# Access Compliance Report

## Public Rights-of-Way

### (Curb Ramps)

Intersection ID: 2478	Main Street: WHISTLER'S_CHASE_DR	Cross Street: HIGHLAND_CREEK_PY	Location: S
ADA ID: FB45D96374A2	Ramp Type: PerpDiag	Initial Pass/Fail: Fail	Overall Compliance: No
Severity Score: 36.25			
Codes/Mitigation Info/Possible Solution		Field Measurements/Component Compliance

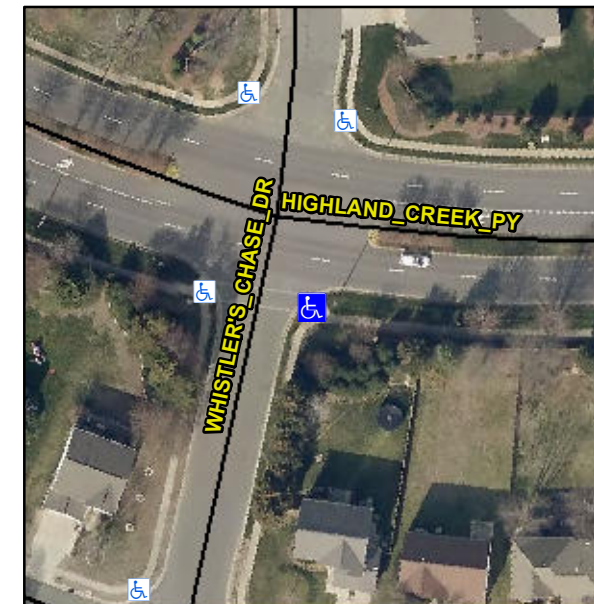
**R304.5.1, R304.5.3**

Compliance	Description	Data	Compliance	Description	Data
N/A	Ramp Length (in)	82.0	Yes	Ramp Slope (%)	6.9
No	Ramp Width (in)	25.5	No	Ramp XSlope (%)	5.0
N/A	Flare Type LT	N/A	N/A	Flare Type RT	N/A
N/A	Flare Slope LT (%)	N/A	N/A	Flare Slope RT (%)	N/A
N/A	Flare Traversable LT?	N/A	N/A	Flare Traversable RT?	N/A
N/A	Landing Length (in)	N/A	N/A	DWS Provided?	N/A
N/A	Landing Width (in)	N/A	N/A	DWS Contrast?	N/A
N/A	Landing Slope (%)	N/A	N/A	DWS Length (in)	N/A
N/A	Landing X Slope (%)	N/A	N/A	DWS Full Width?	N/A
N/A	Landing Curb? (Y/N)	N/A	N/A	DWS Offset (in)	N/A
N/A	Shared Landing?	N/A			
N/A	Gutter Ponding?	N/A	N/A	Gutter Slope (%)	N/A
N/A	Gutter Lip Ht (in)	N/A	N/A	Gutter X Slope (%)	N/A
N/A	Painted X Walk1?	No	N/A	Painted X Walk2?	Yes
	X Walk 1 Direction	To NE		X Walk 2 Direction	To NW
N/A	X Walk 1 Width (in)	N/A	N/A	X Walk 2 Width (in)	97.0
	X Walk 1 Slope (%)	8.8		X Walk 2 Slope (%)	3.2
	X Walk 1 X Slope (%)	4.0		X Walk 2 X Slope (%)	6.5

N/A	Ramp inside XWalk1?	N/A	N/A	Ramp inside XWalk2?	Yes
	Road Slope (%)	2.7	N/A	Clear Space?	N/A
	Road X Slope (%)	6.8	N/A	Clear Space to XWalk (in)	N/A
N/A	Any Obstructions?	N/A	N/A	Storm Grate/Utility Hazard?	N/A
	Obstruction Type			Storm Grate/Utility Type	
		N/A			N/A
			Yes	Surface Condition? (G/P)	Good

**Remove & Replace Curb Ramp With Two New Directional Ramps or Equivalent.**
